PROBLEM:

In the H2, a knocking noise may develop in the right engine cover which sounds like a worn, loose clutch. The knock is caused by play between the crankshaft, woodruff key, and primary pinion. If the knocking is allowed to continue the woodruff key may be damaged.

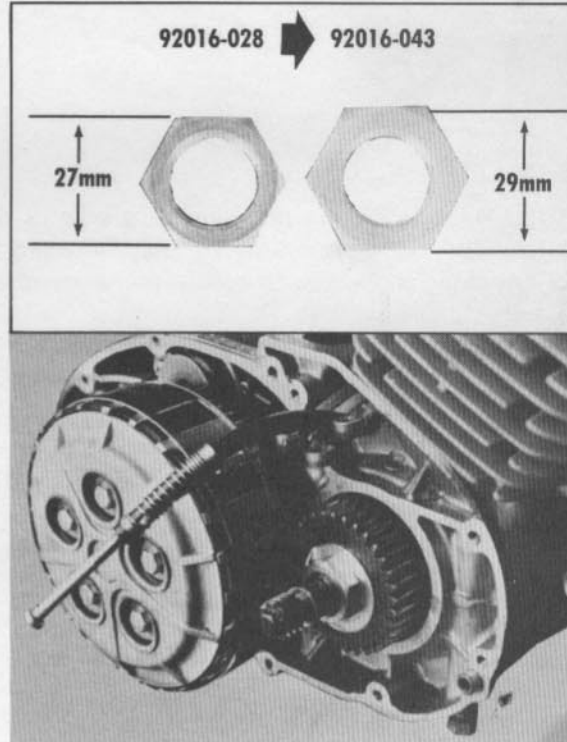
Surprisingly, the primary pinion nut does not loosen (turn) on the crankshaft. Instead, the lockwasher is crushed, relieving the pinion of nut tension. Then the gear is held from twisting only by the woodruff key. As the drawing below shows, the "crush" area on the lockwasher, which is determined by the I.D. of the pinion gear and the O.D. of the pinion nut, is very small.

The knocking results from the pinion keyway hitting the woodruff key as the pinion twists on the crankshaft.

A new larger nut, with a 29mm O.D., is used to increase the lockwasher crush area and eliminate washer extrusion. The larger nut has been installed in all H2's after engine number H2E-05228.
